Development Permit Panel

2. Development Permit DP 12-600815

APPLICANT: IBI-HB Architects

PROPERTY LOCATION: 8380 Lansdowne Road

ELEVATION FROM ADJACENT PROPERTY LOOKING TOWARDS STEPPED PLANTER

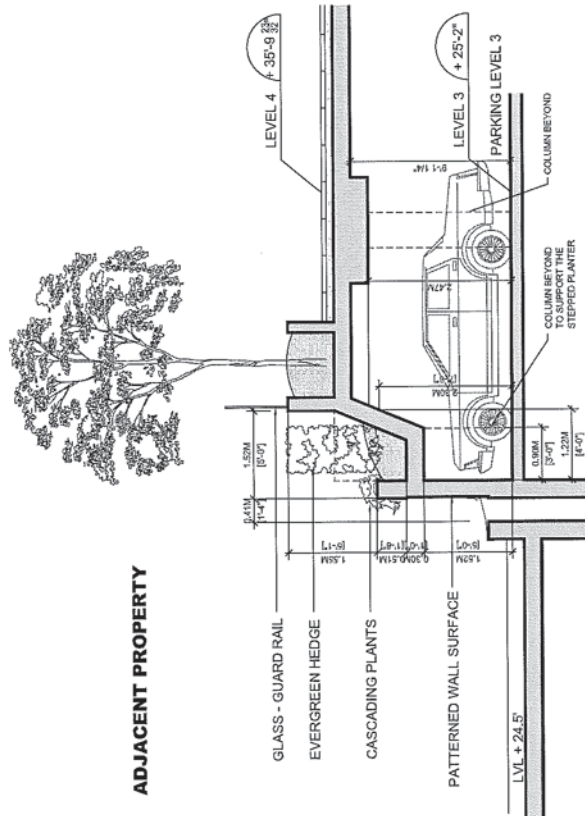
- space between the podium level of the adjacent building and higher podium of the subject development is not welcoming; space between these two podiums with a 12-foot height differential appears dark; consider incorporating public art at adjacent property where this project creates a canyon-like space to make it a more invigorating space; *(Please see revised section through the west wall adjoining the neighbor and the revised landscape plan. The west wall height is further reduced and is treated with textured pattern treatment and stepping planters along the top line)*

TOWER ENTRY - ELEVATION

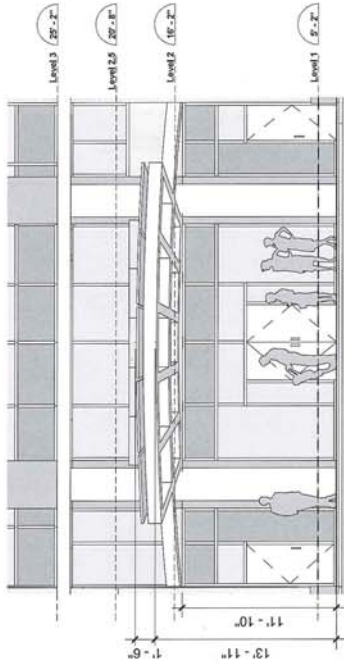
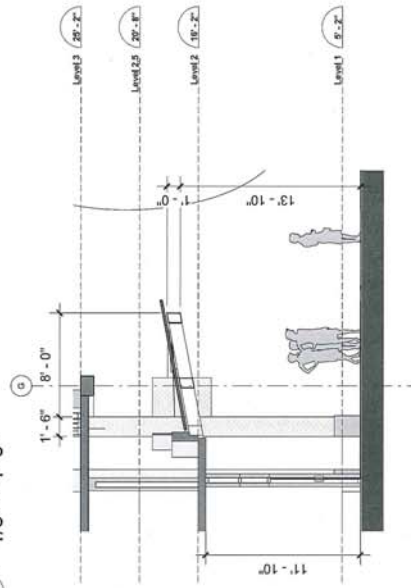
- tower is quirky and does not meet the ground well at the main entry on Cooney Road; applicant needs to address the residential entrance at Cooney Road in a stronger way; appears weak at present; *(Please see revised east elevation and the detail drawings showing the glazed metal canopy highlighting the building's main entrance)*
